Product Change Notification

- PCN Number** : PCN193

- Product Category** : Sensor & Transducers – Electromagnetic Transducers.

AFTER CHANGE

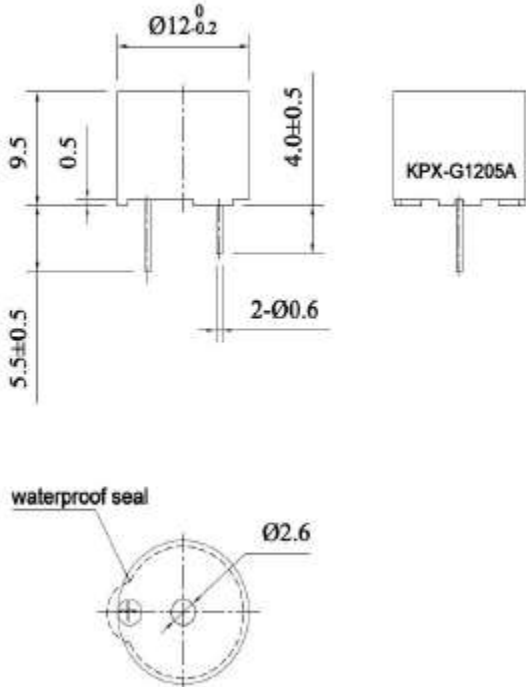
- Reason For Change** : Due to Tooling Re-build original top side part number engraving apply laser marking on flank side as below shown.
